ΘΕΜΑ: «Πληροφορίες σχετικά με τα θέματα πυροπροστασίας του έργου κατασκευή και λειτουργία ξενοδοχειακής μονάδας, ιδιοκτησία της εταιρείας 'Μαρίνος Σωτηρίου και Άλλη', στην κοινότητα Πάνω Πλάτρες, στην επαρχία Λεμεσού»

Fire Safety Strategy Report

Tree Hotel Troodos - Cyprus

31.07.2019 | FEC Ref. S 4216-1000 Rev 0 | FSS Report

Πίνακας 3: Αλλαγές στο σχεδιασμό του προτεινόμενου έργου

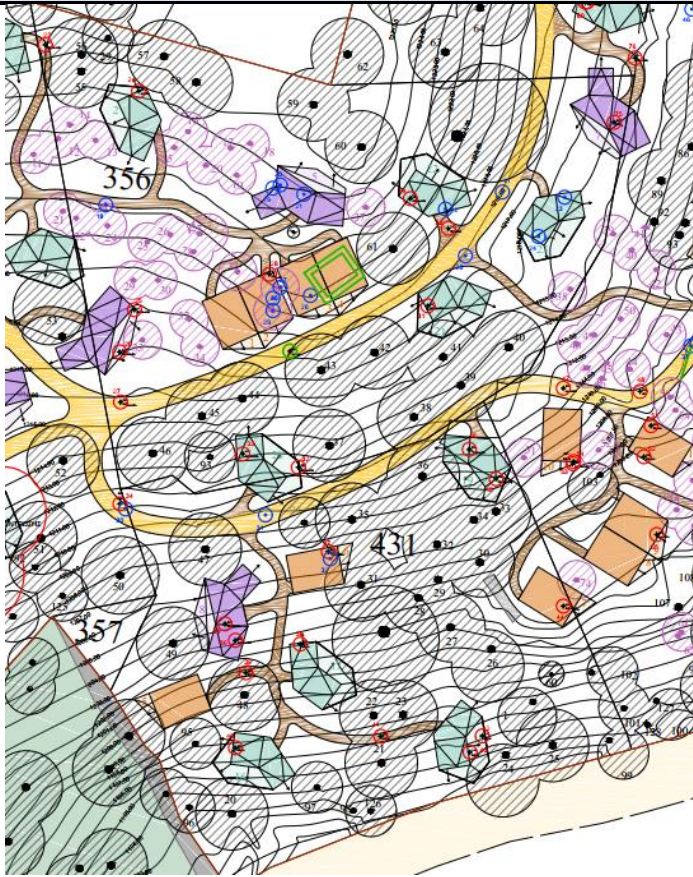
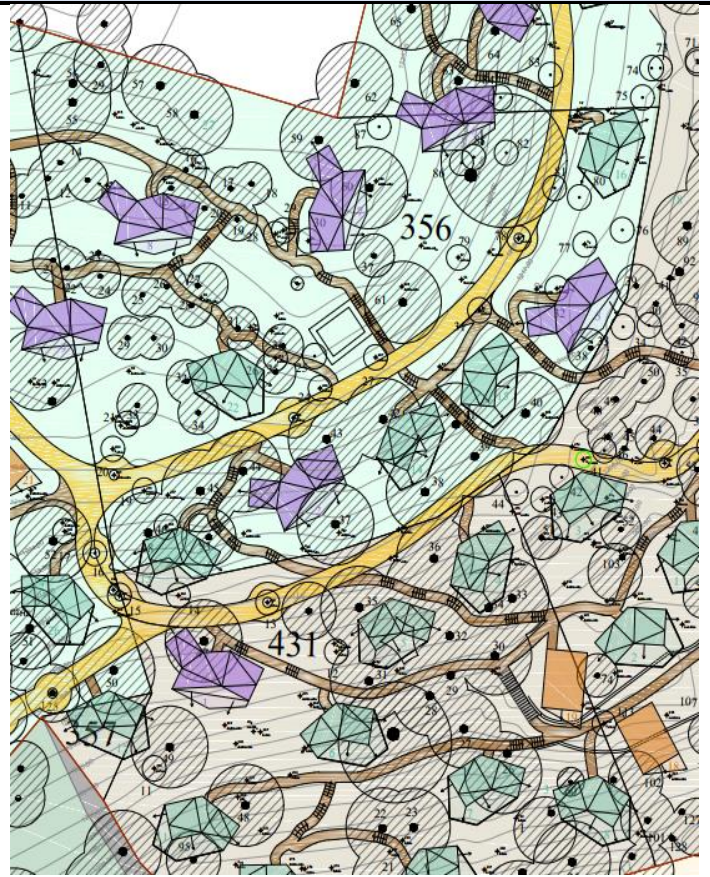
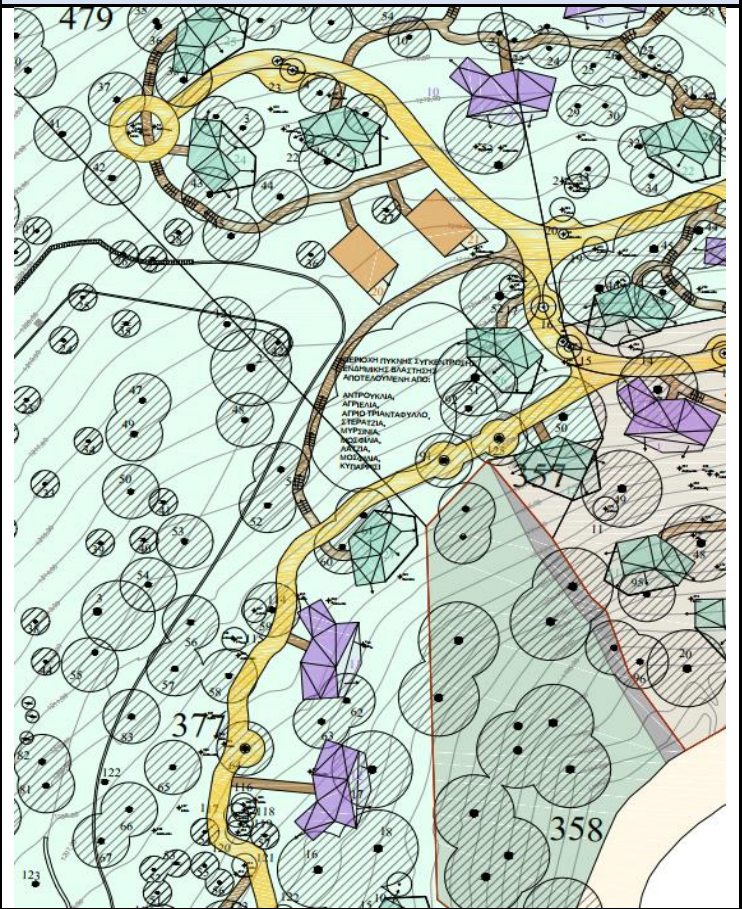
Στον Πίνακα 3 παρουσιάζονται οι αλλαγές που έγιναν στο σχεδιασμό του προτεινόμενου έργου. Στην πρώτη στήλη του Πίνακα 3 παρουσιάζεται ο αρχικός σχεδιασμός, ενώ στη δεύτερη στήλη η αναθεωρημένη έκδοση. Επίσης, στο επισυναπτόμενο στην παρούσα επιστολή Σχέδιο του Παραρτήματος 4, παρουσιάζεται ο Αρχικός Σχεδιασμός του Προτεινόμενου Έργου, ενώ στο επισυναπτόμενο Σχέδιο του Παραρτήματος 3 ο Αναθεωρημένος Σχεδιασμός Προτεινόμενου Έργου.

Ο νέος σχεδιασμός παρουσιάζεται στο Σχέδιο του Παραρτήματος 3, το οποίο επισυνάπτεται στην παρούσα επιστολή. Σύμφωνα με το νέο σχεδιασμό δεν πρόκειται να αφαιρεθούν δέντρα και θάμνοι κατά την χωροθέτηση των καμπινών στην πολεοδομική ζώνη προστασίας Z1. Η εκρίζωση δέντρων και θάμνων θα περιοριστεί στην οικιστική πολεοδομική ζώνη, όπου βάσει σχεδιασμού πρόκειται να επηρεαστούν άμεσα 20 Πεύκα (*Pinus brutia*) και 17 ακόμα άτομα. Συγκεκριμένα, πρόκειται για 10 είδη Αντροκλιάς (*Arbutus Adrachne*), 1 είδος Λατζιάς (*Quercus alnifolia*), 1 είδος αχλαδιάς, 4 Κέδρους (*Cedrus bernifolia*) και 1 Μερσινιά (*Myrtus communis*).

DRAWING TITLE: REVISED MASTERPLAN AND AFFECTED TREES-PLANTS & ELEMENTS_ 67 CABINS		
DATE: 26/06/2023	SCALE: 1:500 A1	Project No: 2021
DR: M.P.	APPROVAL: K.P.	DRAWING: 01

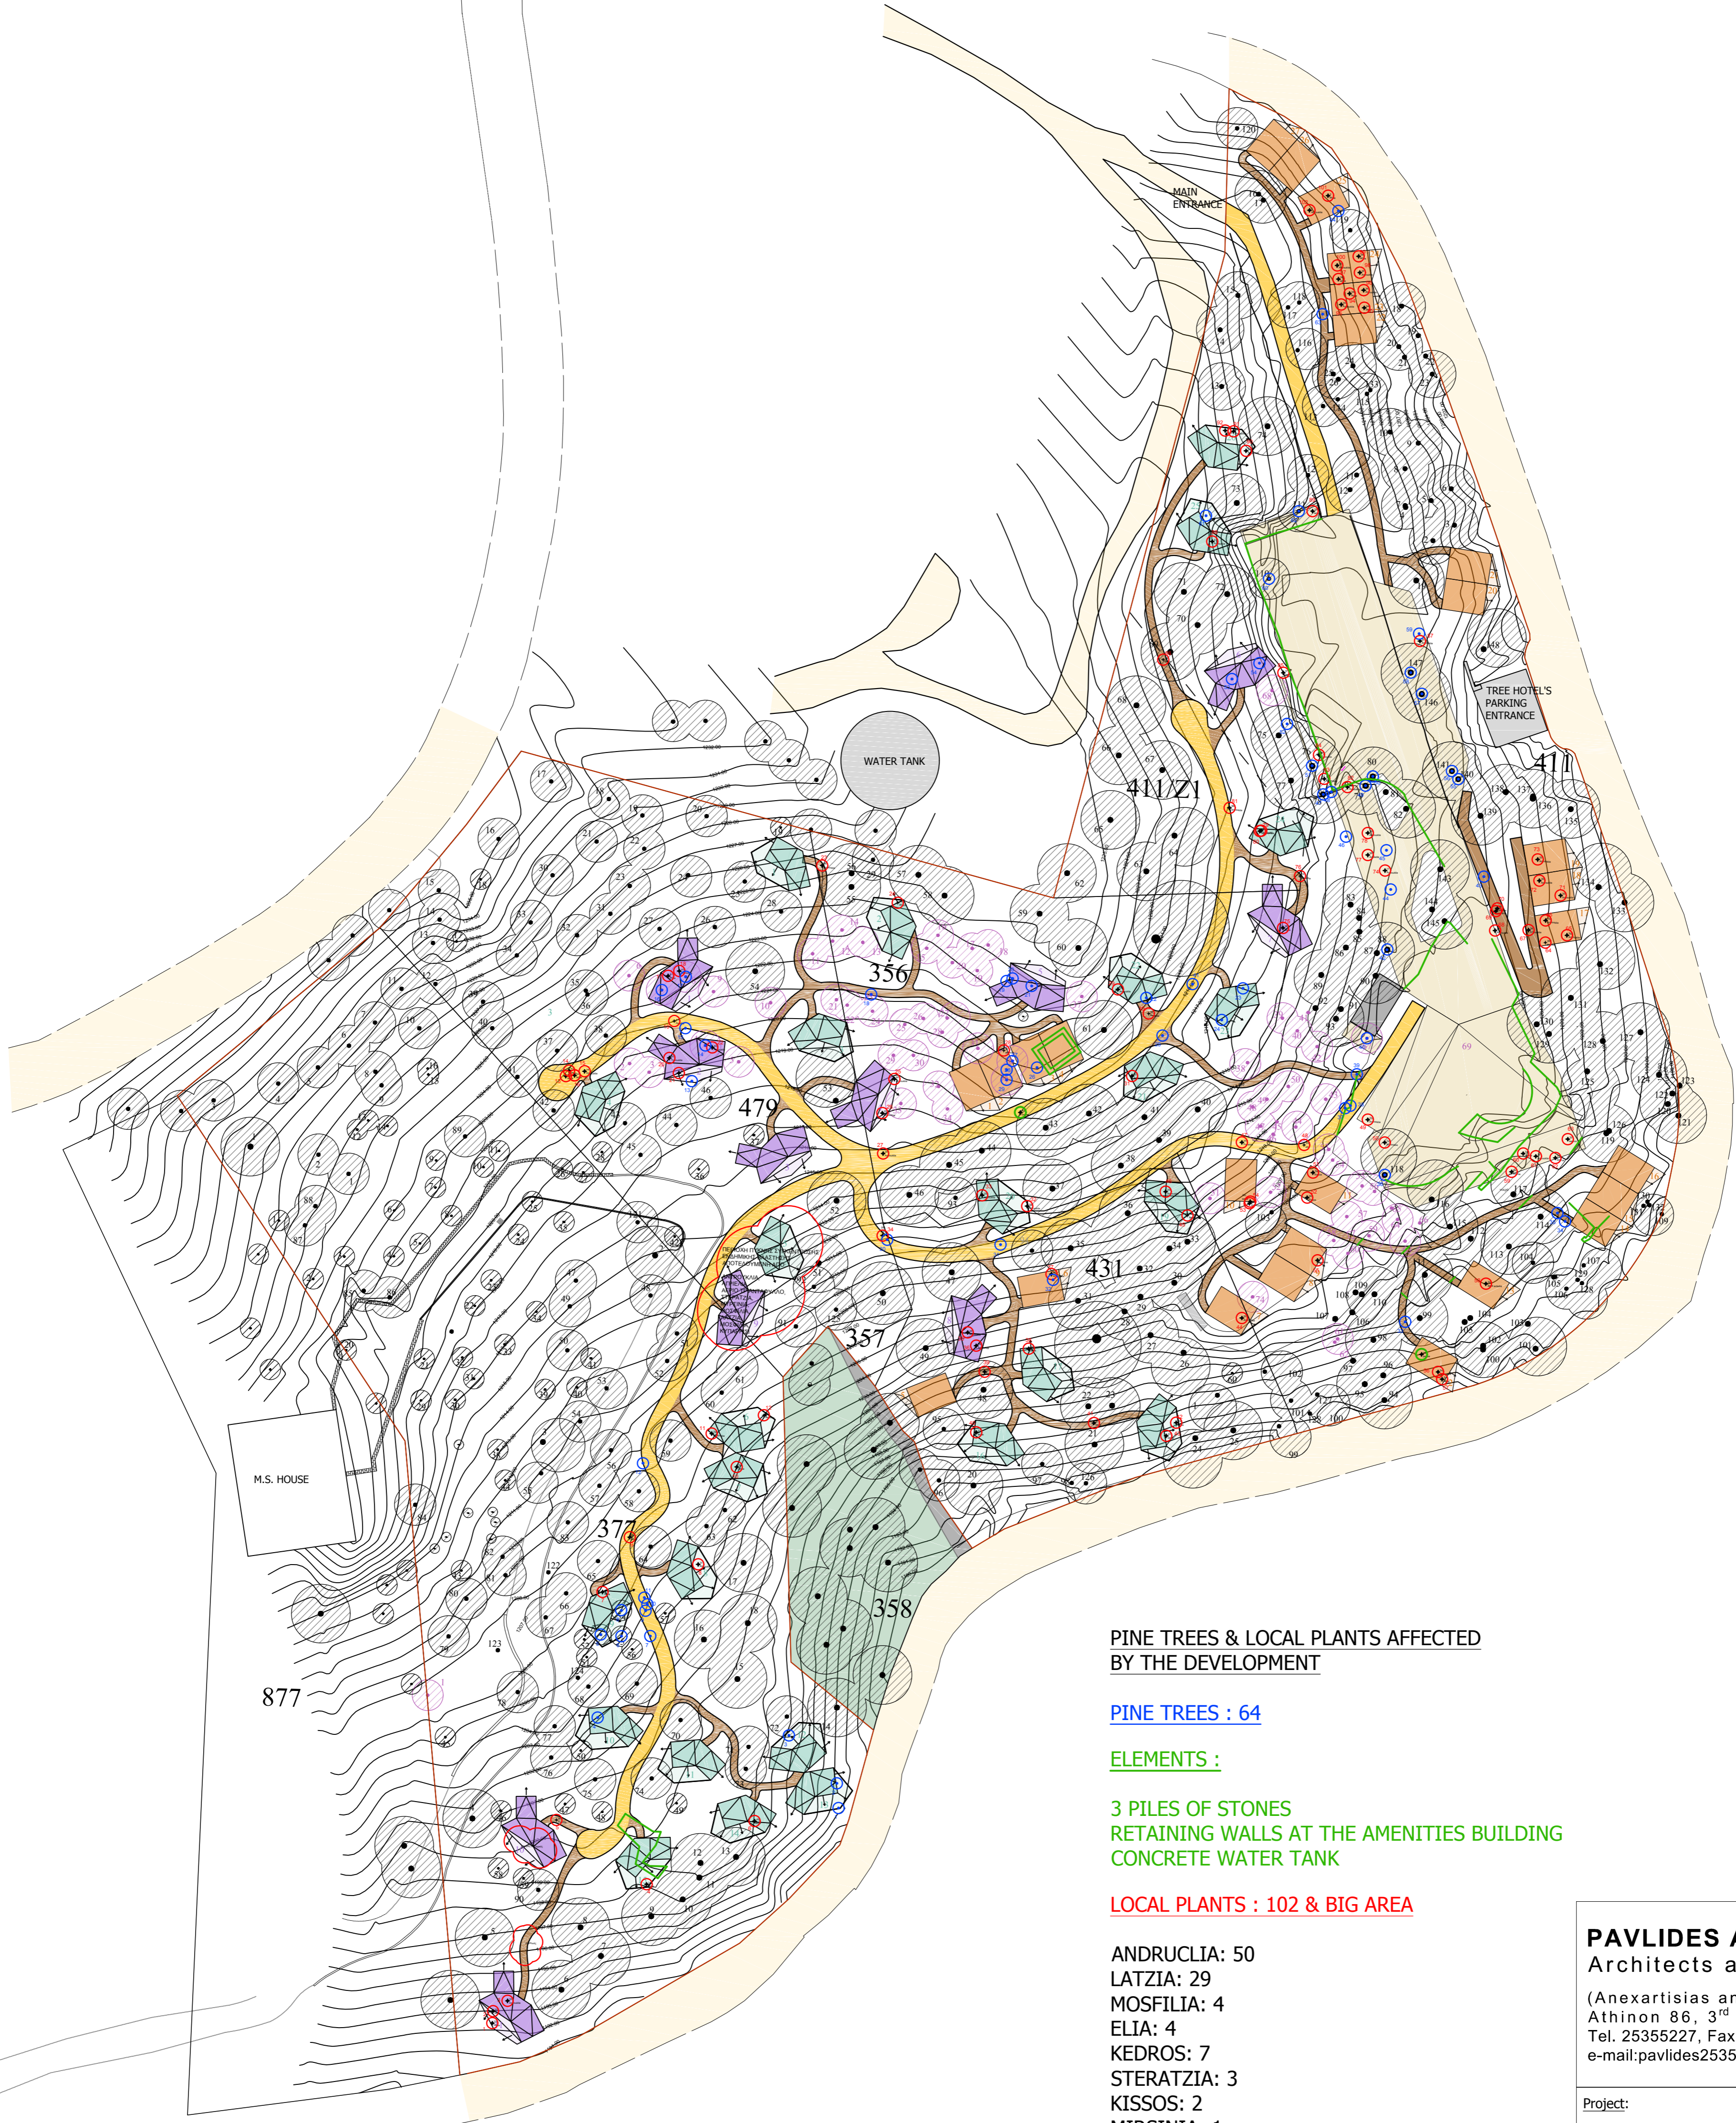
- Total pine-trees to be affected : 20 (previously: 64)
- Total local plants to be affected : 17 (previously: 102 +)
